SCE275 Service Parts

SERVICE BULLETIN

Subject: SCE275 Model Series Change

Controller location, G series and up

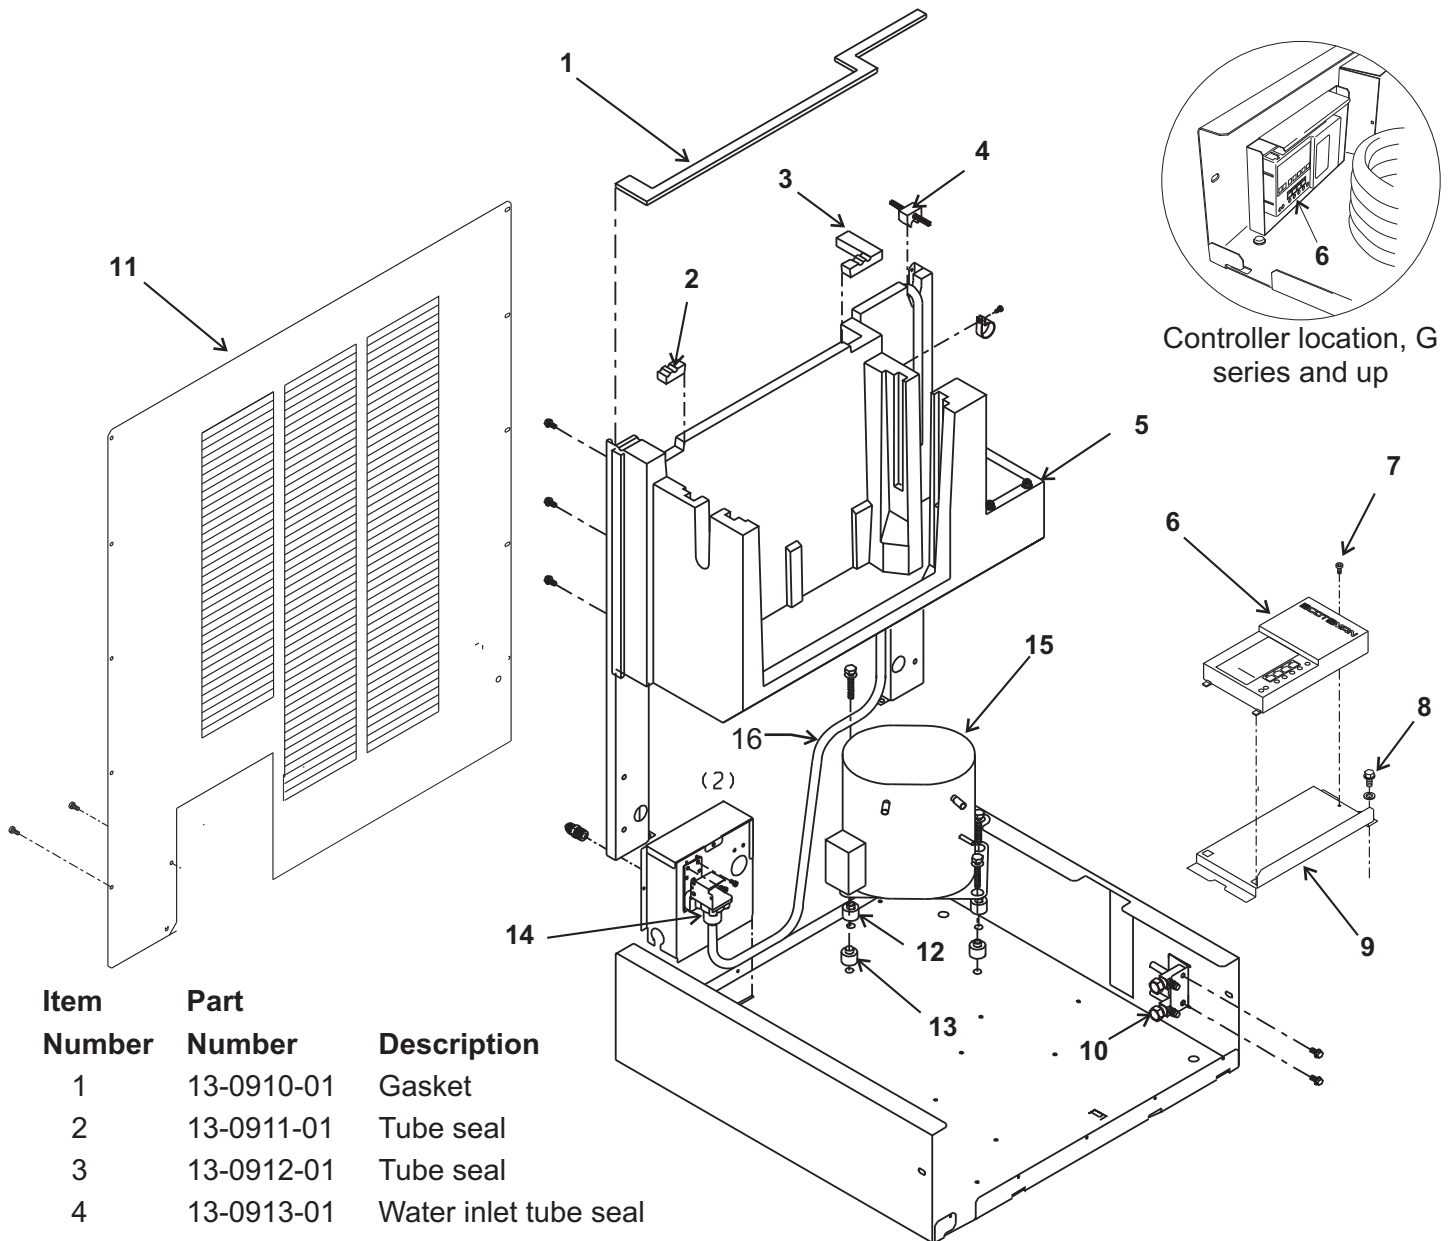
The G series moved the controller to the left side of the chassis.

New Location for Controller

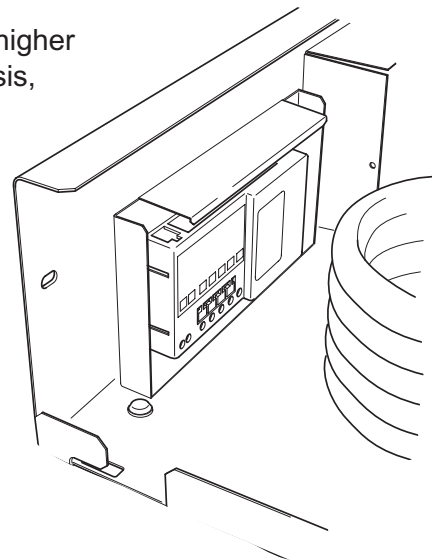
The SCE275 is now being manufactured as a G series. G series and higher SCE275s have their AutoIQ controller on the left side wall of the chassis, instead of the right side chassis floor. The new location provides improved protection from water and debris.

Although the controller's buttons and lights are somewhat out of sight in the new location, they can be easily seen by flashlight.

Because of the controller move, the wire harnesses have also changed.
